BYLAW C-7991-2020**A Bylaw of Rocky View County, in the Province of Alberta, to adopt the Ascension Conceptual Scheme**

SCHEDULE 'A'
FORMING PART OF BYLAW C-7991-2020

A Conceptual Scheme affecting Block 6, Plan 8710757, NE-18-25-2-W5M; Block A, Plan 9212196, SE-19-25-2-W5M; a portion of SE-19-25-2-W5M; and SW-19-25-2-W5M, herein referred to as the Ascension Conceptual Scheme.

Figure 17 - 15m Urban Residential

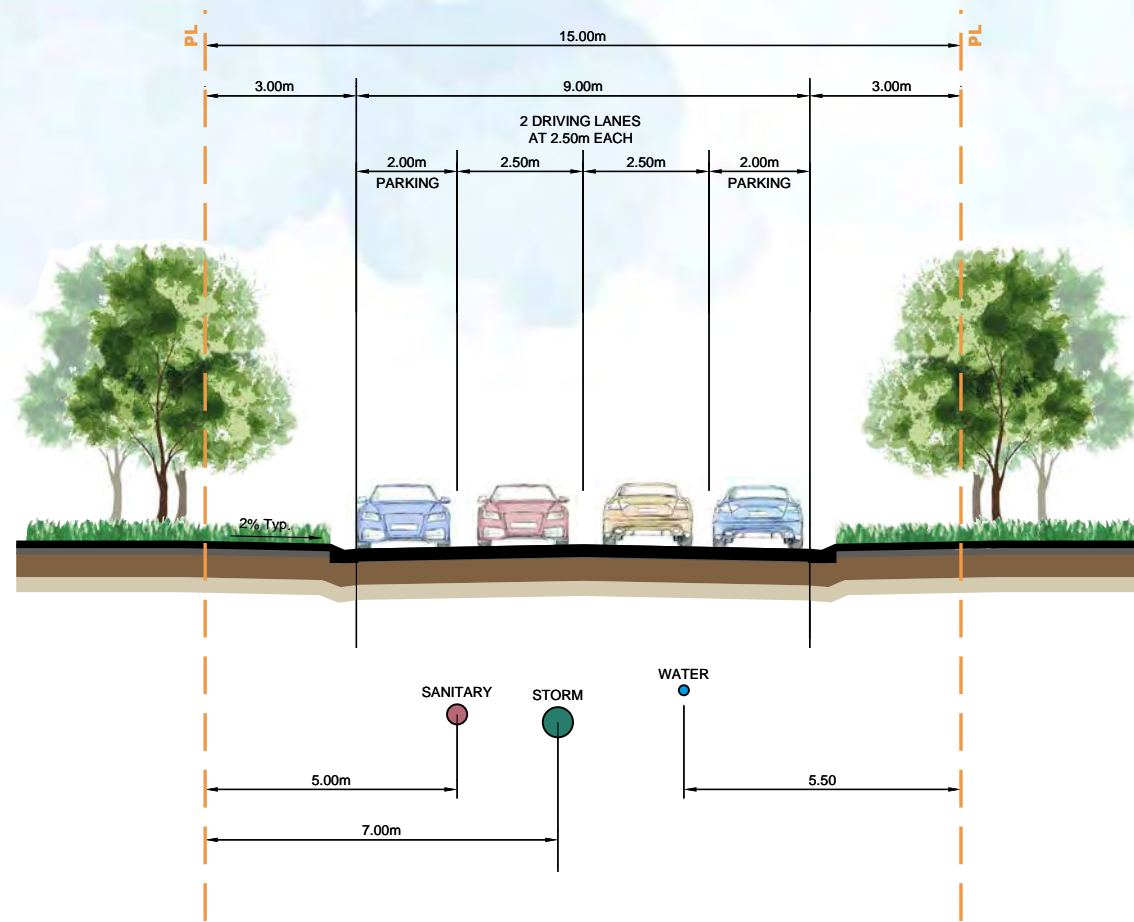
Figure was updated, Formerly two Figures "Single-Loaded Residential Road Design" & "Double-Loaded Residential Road Design"

Figure 18 - Regional Storm Water Servicing Plan

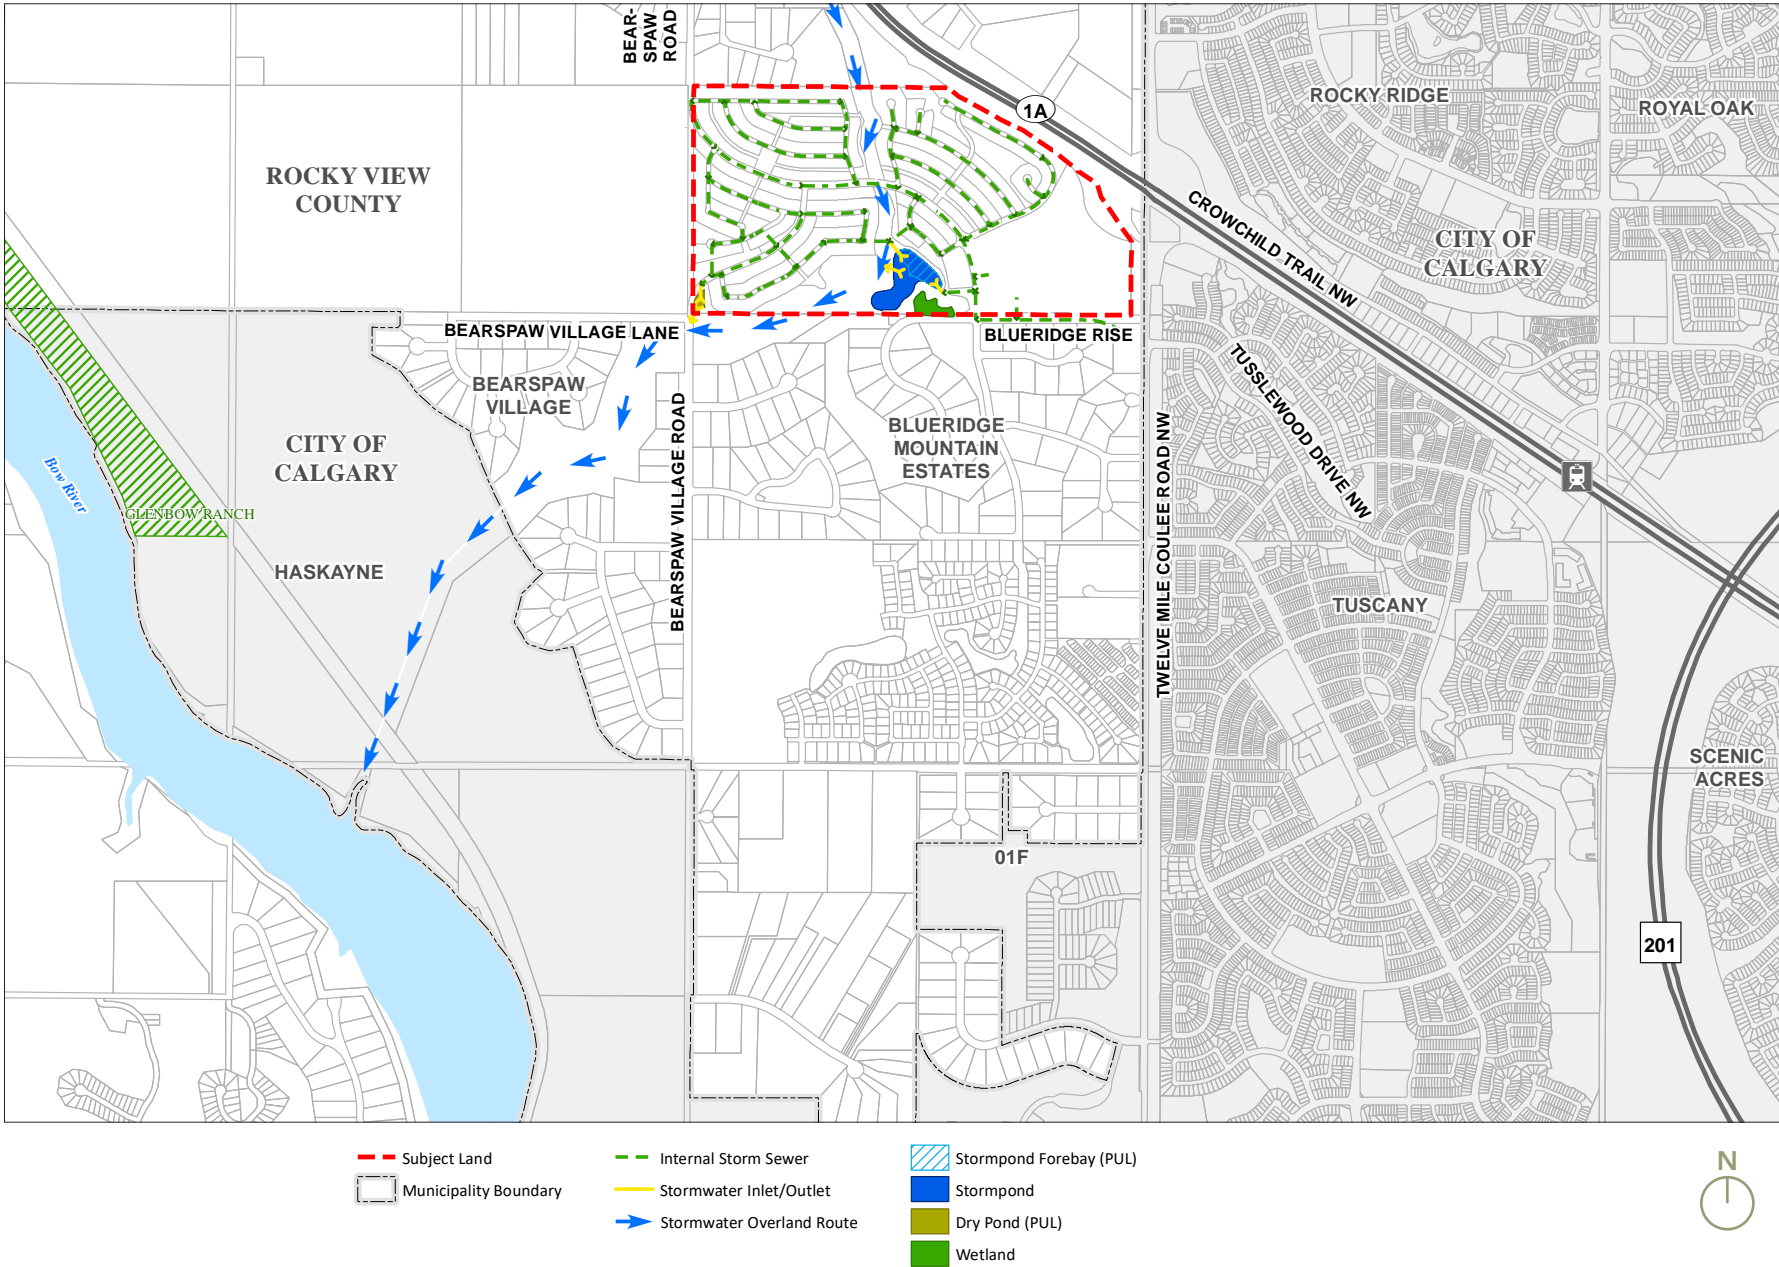
Formerly Figure 19 - Figure was updated

Figure 20 - Regional Water Servicing Plan

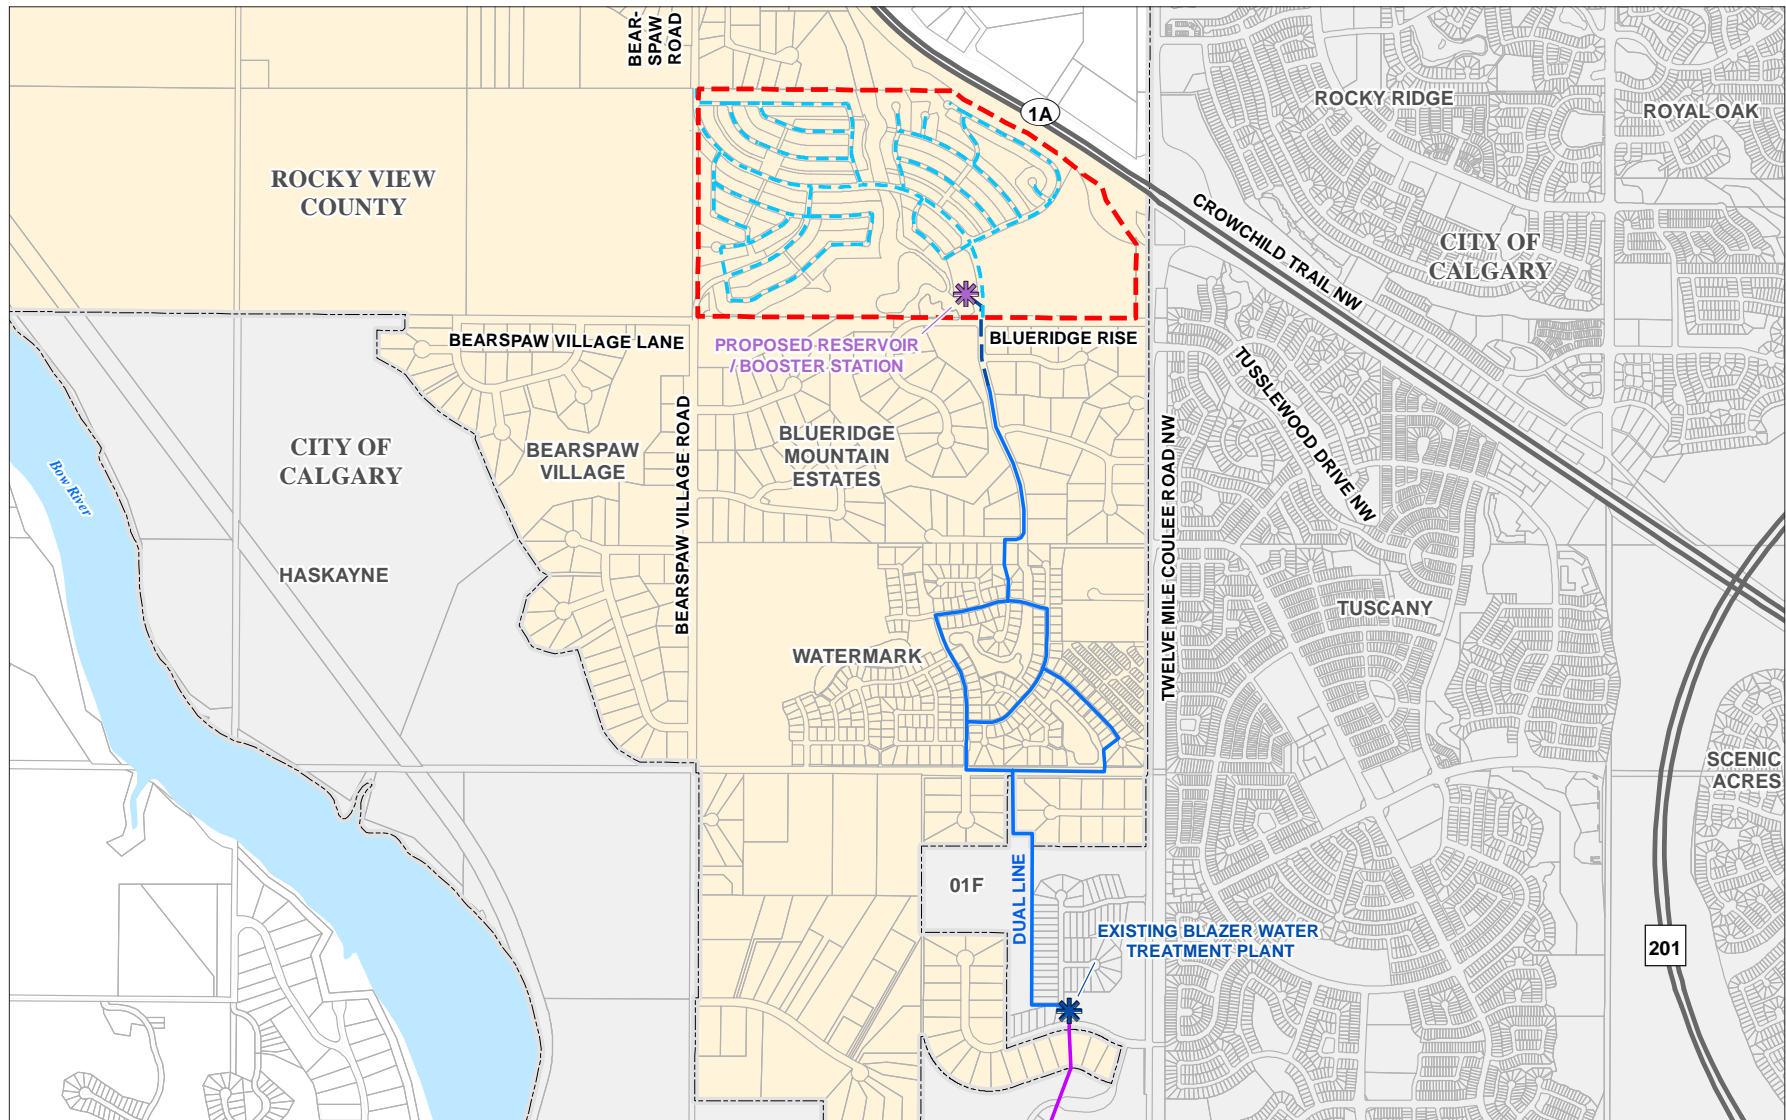
Formerly Figure 21 - Figure was updated

Figure 22 - Regional Wastewater Servicing Plan

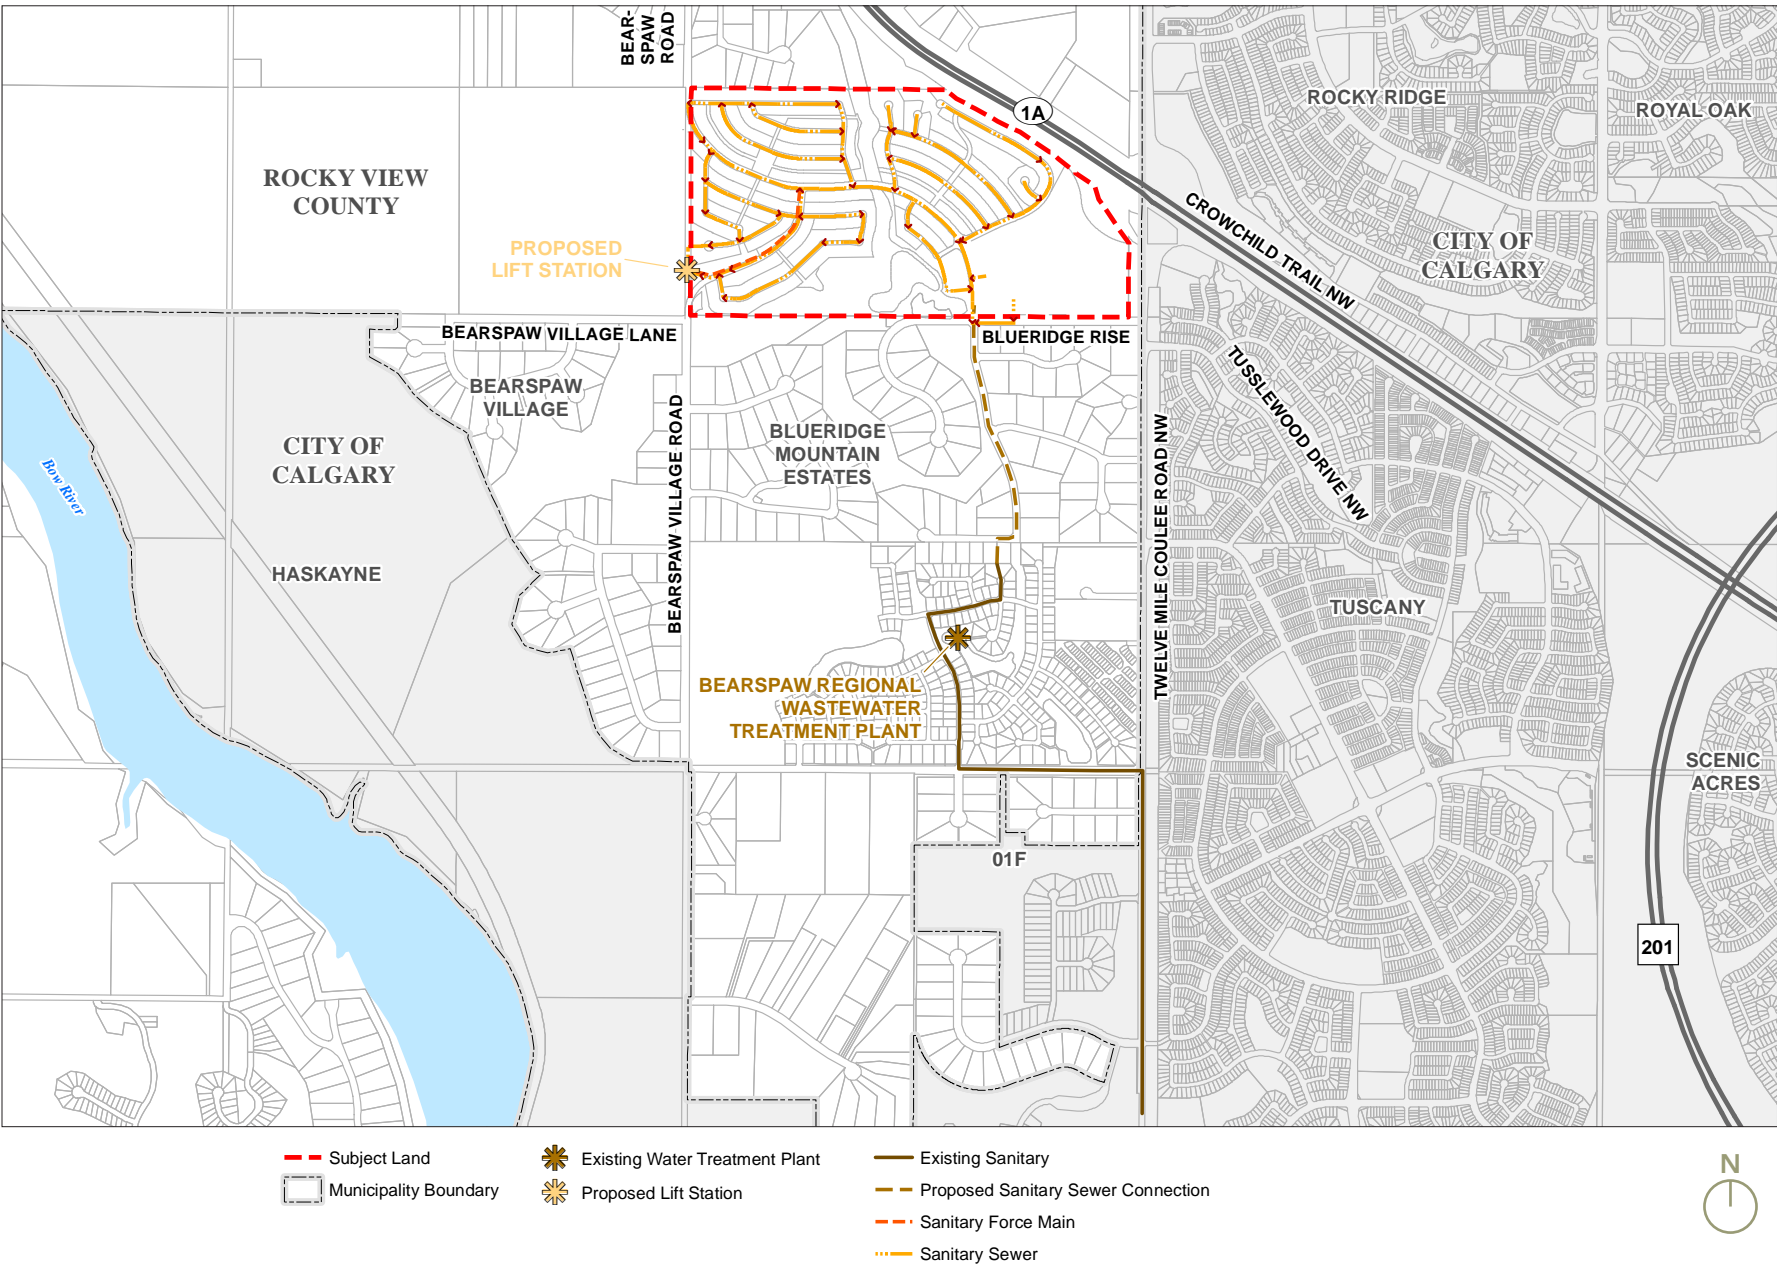
Formerly Figure 23 - Figure was updated
